(NASA-CR-172074) EVALUATION OF DSS-14
 PEDESTAL-REVIEW OF TOP SURFACE REPAIR
 PROCEDURES (Construction Technology Labs.)
 48 p HC A03/MF A01

Report To
JET PROPULSION LABORATORY
California Institute of Technology
Pasadena, California
JPL Contract No. 956493

EVALUATION OF DSS-14
PEDESTAL-REVIEW OF TOP SURFACE
REPAIR PROCEDURES

May 1983

Fig. 5 Cross Section Through Haunch
Area Indicating Existing
Reinforcement in Repair Area

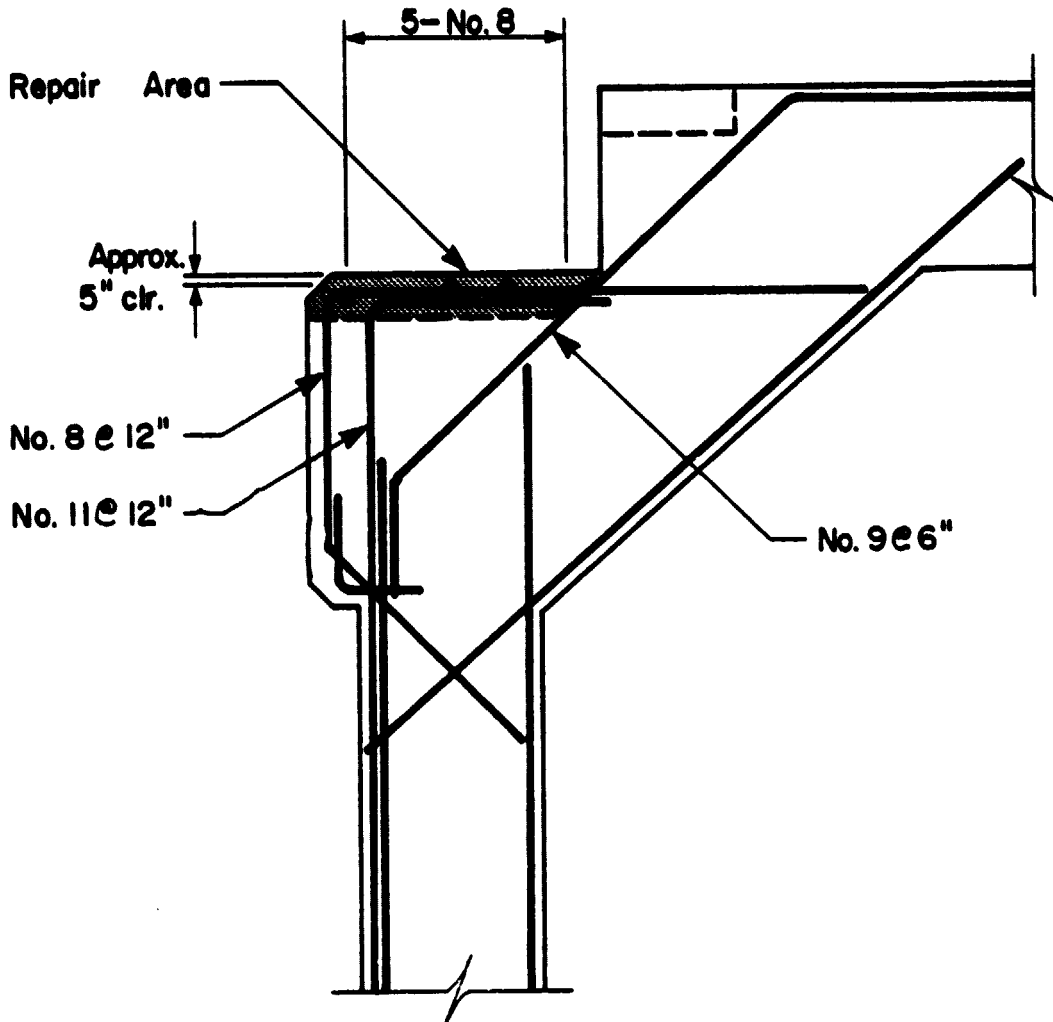
- (2) Staff of JPL indicated that a depth of approximately 8 in. is required to remove concrete to a level of 2 in. below the layer of existing reinforcement in top of the haunch region. Photographs of reinforcement taken during original construction indicates that a depth of approximately 10 in. is required.

Reinforcement within a section of the haunch region to be repaired is shown in Fig. 5. Staff of JPL indicated that the 8 in. depth was chosen to permit removal of concrete down to approximately 2 in. below horizontal layers of reinforcement in the top surface of the haunch. Review of JPL photograph No. 033916 by CTL indicates that approximately 10 in. of material should be removed to be 2 in. below all reinforcement. This depth however would not alter any removal or replacement techniques.

- (7) The existing top layer of circumferential reinforcement is No. 8's at 12 in. on-center placed with approximately 5 in. of cover. It is recommended that, for better crack control of new concrete, a new layer consisting of larger number of smaller diameter bars be added. Thirteen No. 5 bars placed with a 2 in. concrete cover and evenly distributed across the width of the new concrete will be effective for crack control.
- (8) Creep characteristics of the epoxy grout should be evaluated. Creep tests are currently being conducted by CTL. Results will be reported at the end of May 1983.
- (9) Specifications and trial mix design for new concrete are included in the Appendix of this report.
